R E M A R K S

THE DRAWINGS

FIG. 1 ~~RELATED TECHNIQUE~~
PRIOR ART

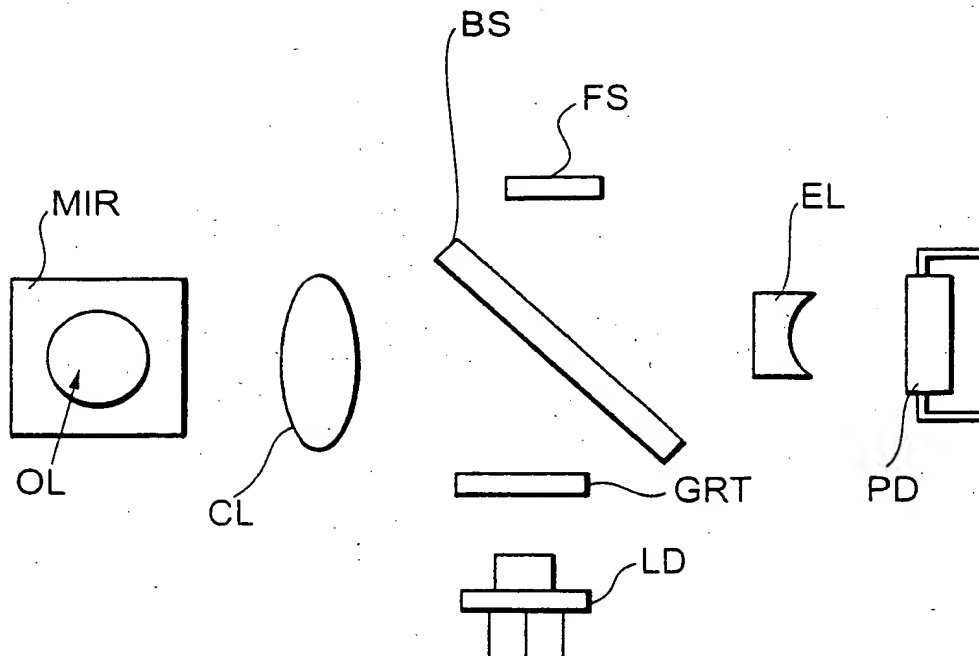
Figs. 1-5 have been amended to change RELATED TECHNIQUE to PRIOR ART, as required by the Examiner.
